Final Report: Category Review of Resident Fish and Sturgeon Projects

INDEPENDENT SCIENTIFIC REVIEW PANEL
ISRP 2020-8 AUGUST 6, 2020

Figure 4 – Age-1 annual survival (a) and abundance (b) of juvenile hatchery fish stocked into the Kootenai River from 1992-2018.

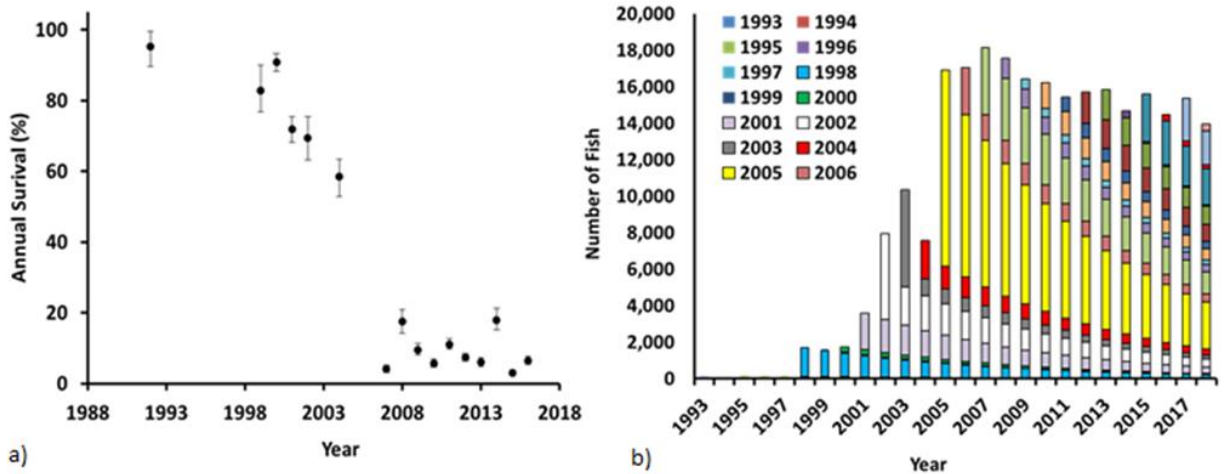
The proponents provided clear and satisfactory responses to all the ISRP requests. They also provided excellent responses to most of our other comments that did not require an immediate response. In future proposals and reports, the proponents should reconcile differences in sturgeon population estimates for the Kootenai. The proponents indicate a current juvenile sturgeon estimate of 12,000 to 15,000, while the Kootenai River Resident Fish Mitigation project (# 198806500; Figure 4) suggests abundance of about 14,000 to 18,000 since 2006. Does the difference reflect different datasets, collection methodologies, or data analysis? An analysis and description of the basis for the differences should be completed.
